SERVICE BULLETIN M20-256
DATE:1-24-95

SUBJECT: Retrofit of Gerdes Fuel Selector Valve with Airight Fuel Selector Valve.

(REFERENCE AD# 95-18-12)

FIGURE SB M20-256-1

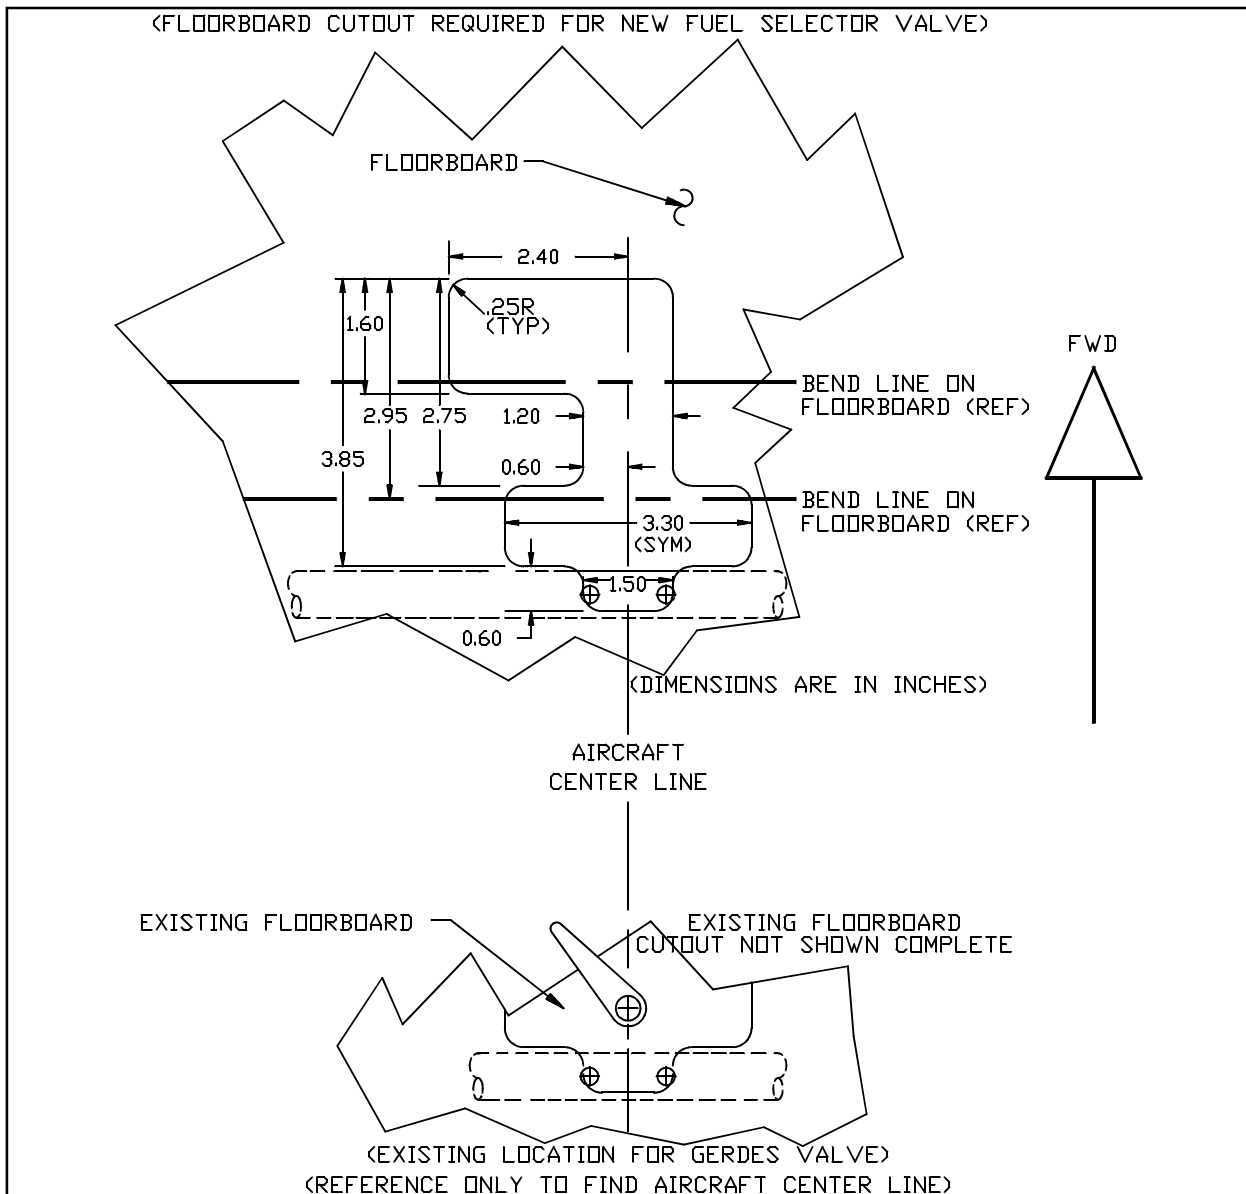
4. Remove existing Gerdes fuel selector valve, A-2580, and 610256-021 tube assembly.
5. Use Figure SB M20-256-1 as a reference to locate aircraft center line and existing bends in floorboard.

6. Layout new hole cutout on floorboard (over existing cutout) for new fuel selector valve according to dimensions of Figure SB M20-256-1.
7. Smooth all edges of cutout on floorboard.
